Chain upgrade and Ink tubes order modification instructions

In order to improve the long-term use of the four-head DTF machine, the ink tubes on both sides of the chain are prone to wear and tear, so upgrades and modifications are made.

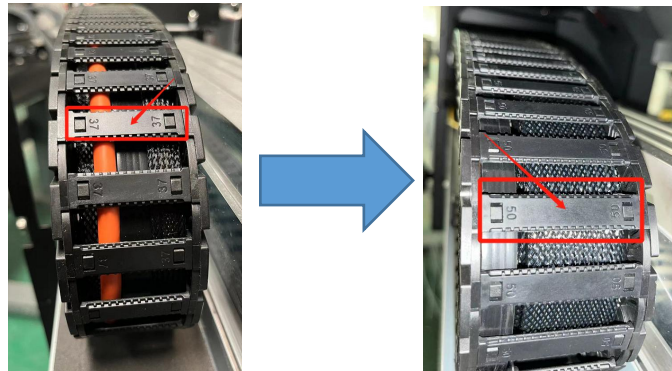
1. Chain size upgrade:

The original chain width is 37mm, and the ink tubes are a little tighter along with some other lines.

2. Ink tubes order update

According to the analysis of the actual situation, most of the ink tube wear problems occur in the ink tubes on both sides of the 8-row tubes. Therefore, the ink tubes on both sides are updated as empty ink tubes, which can prevent the actually used ink tubes from being worn. (modified as shown)

At present, the chain width has been upgraded to 50mm, and there is sufficient space for the layout of ink tubes and some lines, thereby reducing the friction of ink tubes and lines.
